Proposal Request

PROJECT: *(name and address)*
AWSOM
Bentonville, Arkansas

PROPOSAL REQUEST 043

Updates to Doors and Frames from Submittal Notes

L3 - LIFE SAFETY PLAN

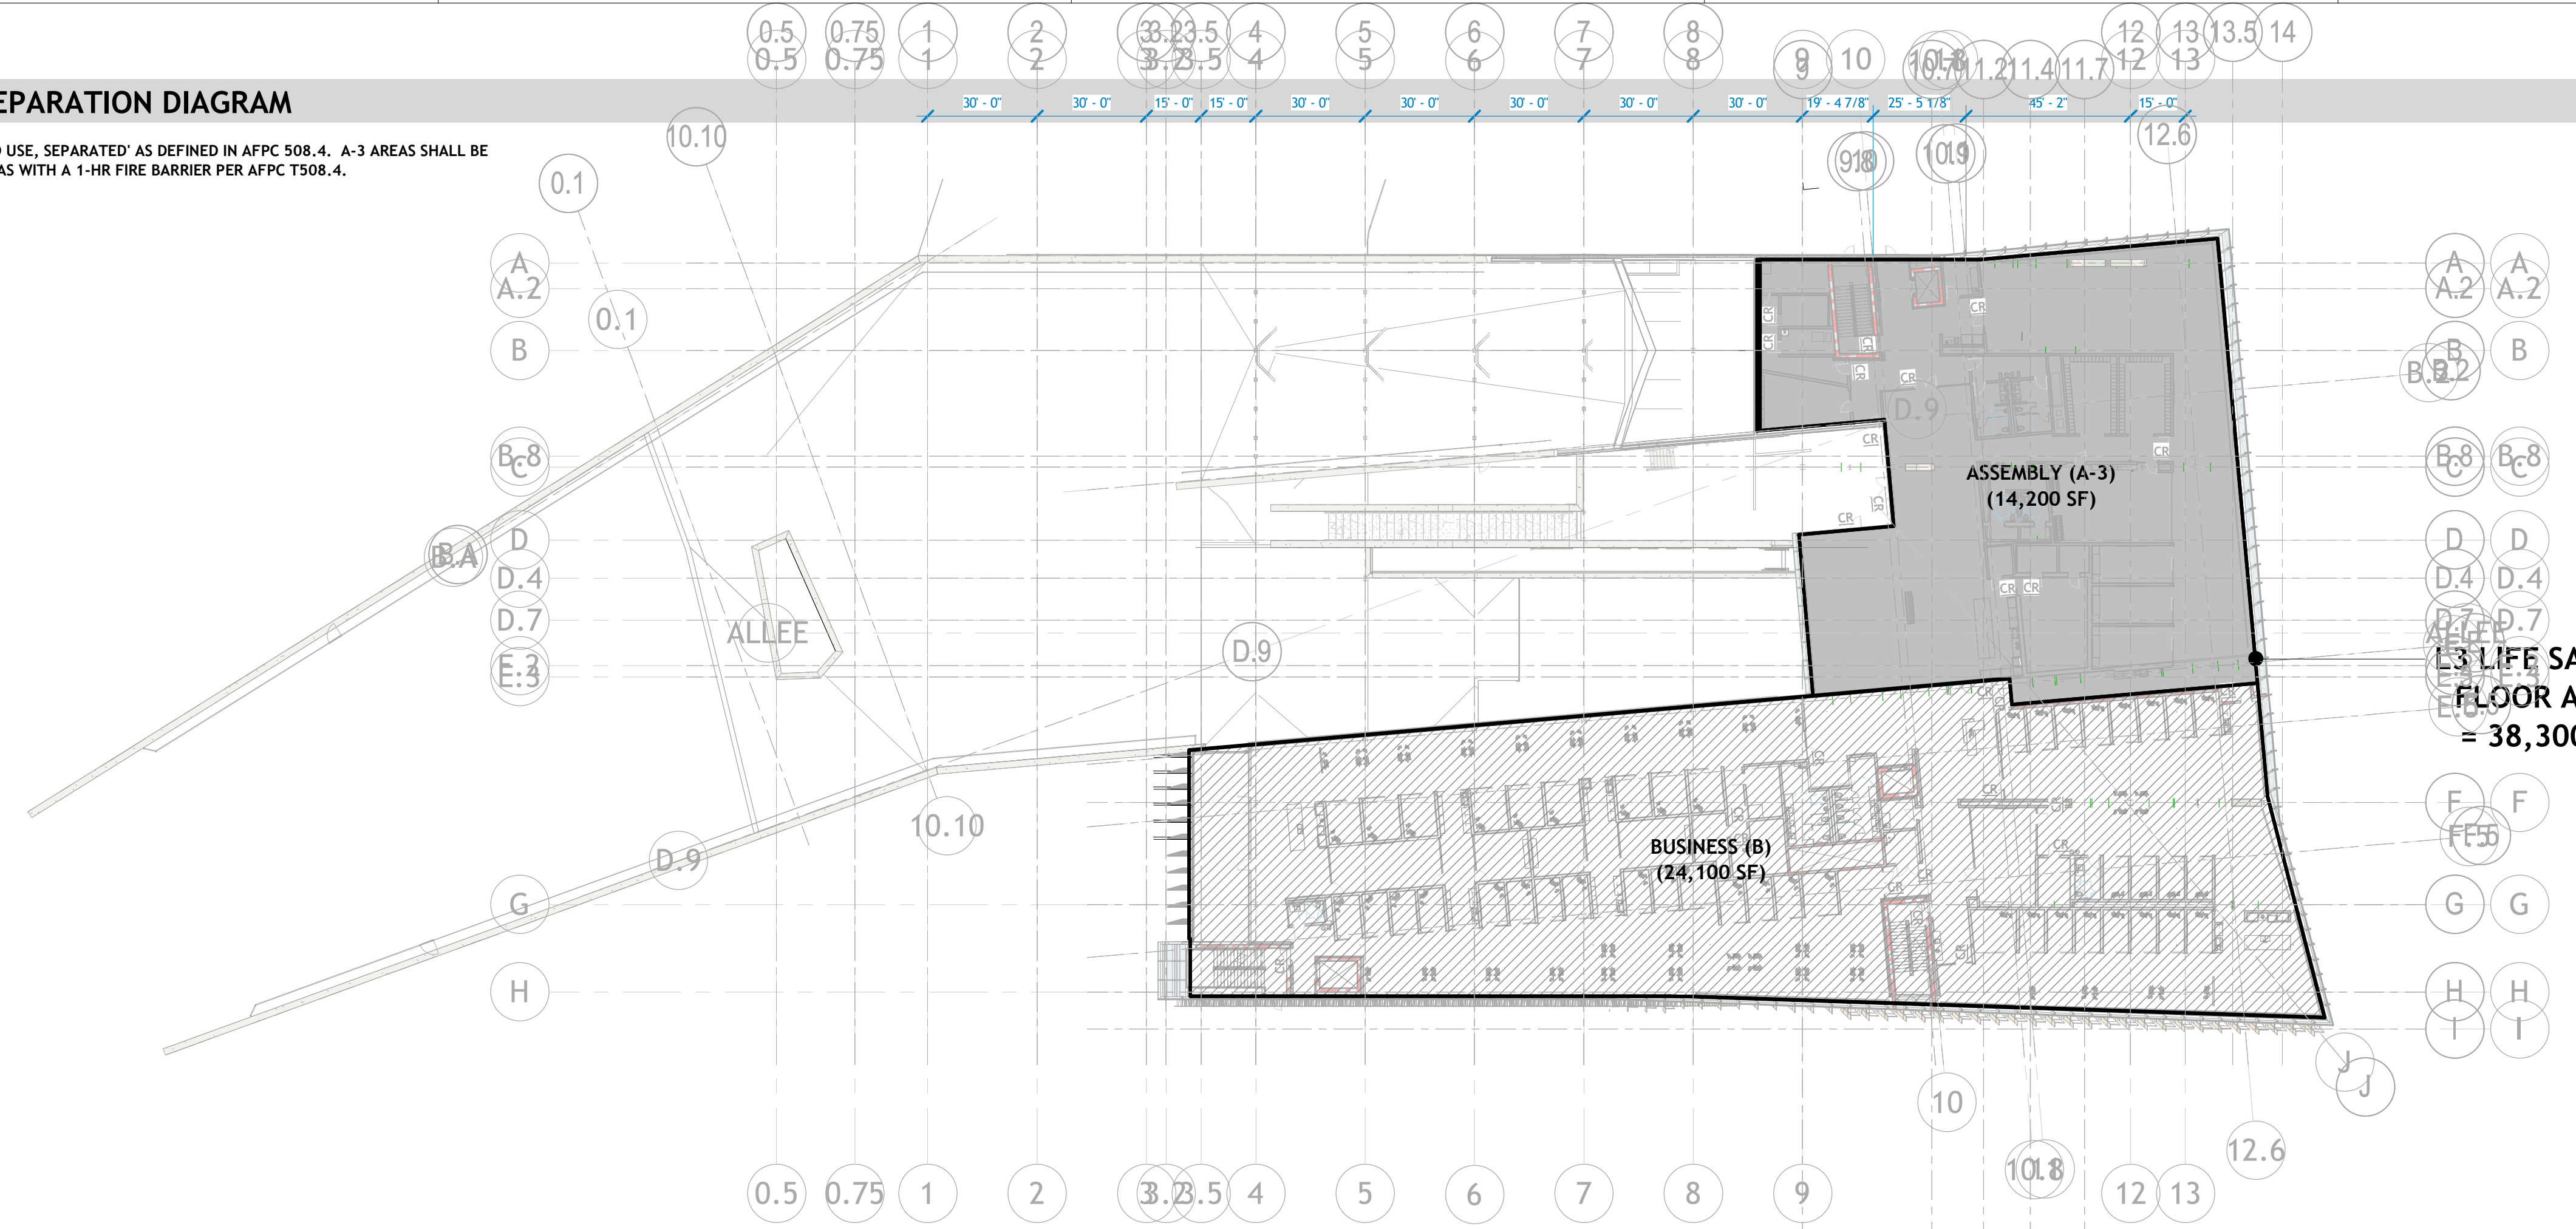
- a) Refer to Revised Sheet **ALS 03 Life Safety Plan – Level 3** with original issue date 02.24.2023 and revision date 04.02.2024.
 - Detail 1 (Floor Plan) – Door rating tags added between office/lobby and student areas at rated divider wall.

9 | L2 TBLH EXTERIOR DOORS WITH APPLIED SLATS
1 1/2" = 1'-0"

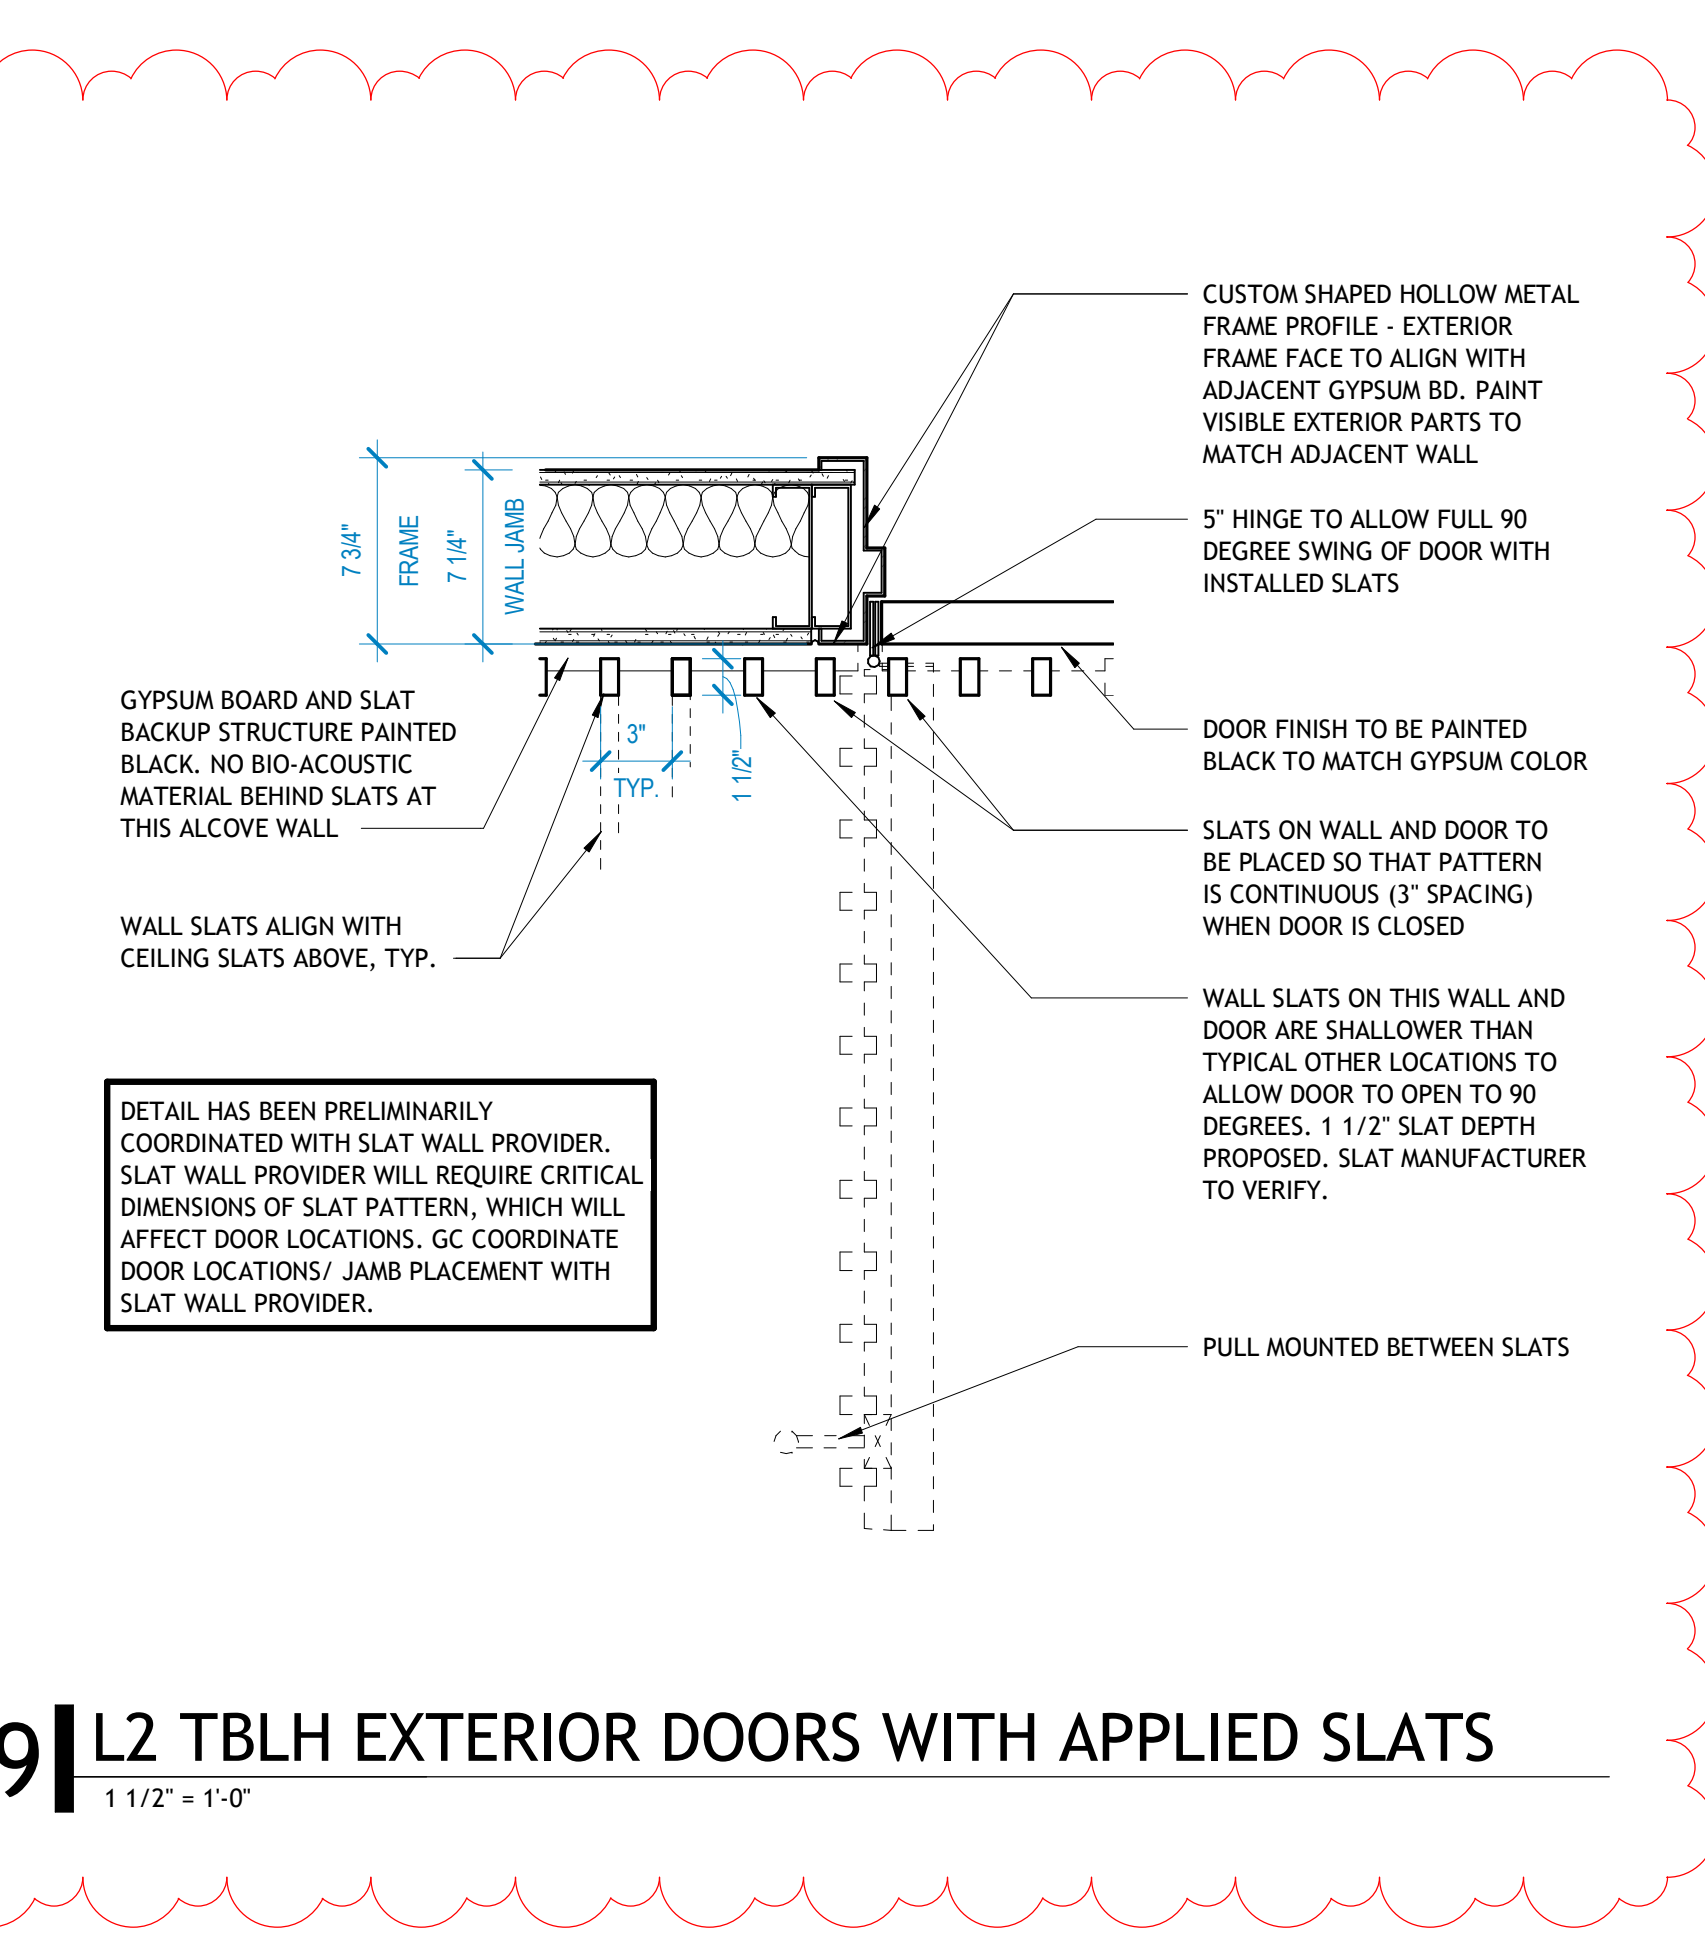
- e) Refer to Revised Sheet **A673 Interior Details** with original issue date 02.24.2023 and revision date 04.02.2024.
- Added detail 9 at Team Based Learning Hall Vestibule Doors at applied slat locations.

- **Door 2309A** - Revise from concealed frame to standard Hollow Metal Frame.
 - **Door 2400A**- Revise from concealed frame to standard Hollow Metal Frame. See new Detail for slats.
